Access Compliance Report Public Rights-of-Way (Curb Ramps)

Intersection ID: 10028937	Main Street: IDLEWILD_RD	Cross Street: N/A	Location: W
ADA ID: 86BB97F4CEF9	Ramp Type: Perp	Initial Pass/Fail: Fail	Overall Compliance: No
Severity Score: 21.25			
Codes/Mitigation Info/Possible Solution		Field Measurements/Component Compliance

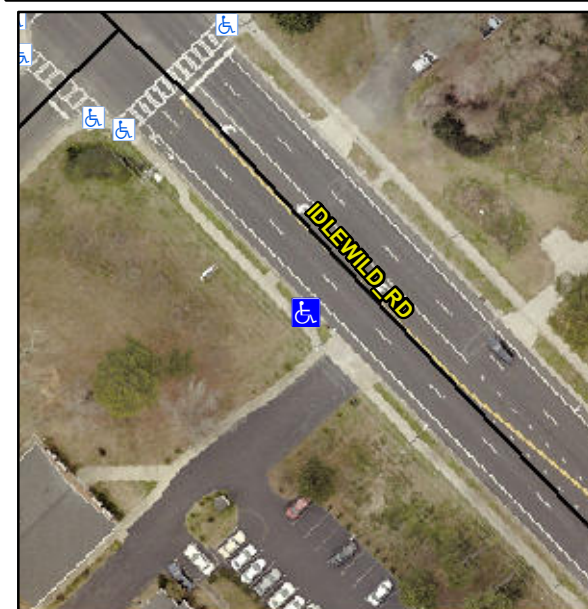
Not Found, R304.5.1, R304.2.2

Compliance	Description	Data	Compliance	Description	Data
N/A	Ramp Length (in)	49.0	No	Ramp Slope (%)	9.9
No	Ramp Width (in)	47.5	Yes	Ramp XSlope (%)	0.9
N/A	Flare Type LT	N/A	N/A	Flare Type RT	N/A
N/A	Flare Slope LT (%)	N/A	N/A	Flare Slope RT (%)	N/A
N/A	Flare Traversable LT?	N/A	N/A	Flare Traversable RT?	N/A
N/A	Landing Length (in)	N/A	N/A	DWS Provided?	N/A
N/A	Landing Width (in)	N/A	N/A	DWS Contrast?	N/A
N/A	Landing Slope (%)	N/A	N/A	DWS Length (in)	N/A
N/A	Landing X Slope (%)	N/A	N/A	DWS Full Width?	N/A
N/A	Landing Curb? (Y/N)	N/A	N/A	DWS Offset (in)	N/A
N/A	Shared Landing?	N/A			
N/A	Gutter Ponding?	N/A	N/A	Gutter Slope (%)	N/A
N/A	Gutter Lip Ht (in)	N/A	N/A	Gutter X Slope (%)	N/A
N/A	Painted X Walk1?	No	N/A	Painted X Walk2?	N/A
	X Walk 1 Direction	To NE		X Walk 2 Direction	N/A
N/A	X Walk 1 Width (in)	N/A	N/A	X Walk 2 Width (in)	N/A
	X Walk 1 Slope (%)	2.1		X Walk 2 Slope (%)	N/A
	X Walk 1 X Slope (%)	1.2		X Walk 2 X Slope (%)	N/A

Remove & Replace Entire Ramp.
